→ Re: Application for Multiple Completion
Sapp Com., Well No. 1
Unit "F", Section 14-27N-8W
San Juan County, New Mexico

Enclosed is a revised diagrammatic sketch of the proposed multiple completion of the captioned Sapp Com., Well No. 1.

SAPP COM., Well No. 1
 Unit "F", Sec. 14-27N-8W
San Juan County, New Mexico

Revised 10/21/76

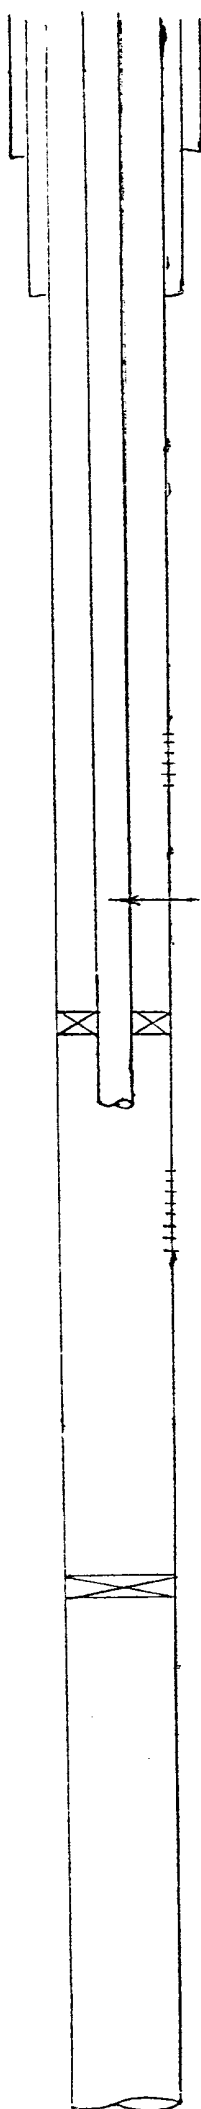
The U. S. G. S. has requested the existing Dakota perforations be squeezed, leaving a minimum of 100' of cement in the casing above the perforations. This sketch has been corrected accordingly.

6500' - (Proposed) Retainer: Squeeze existing Dakota perforations, leaving cement in casing below retainer.
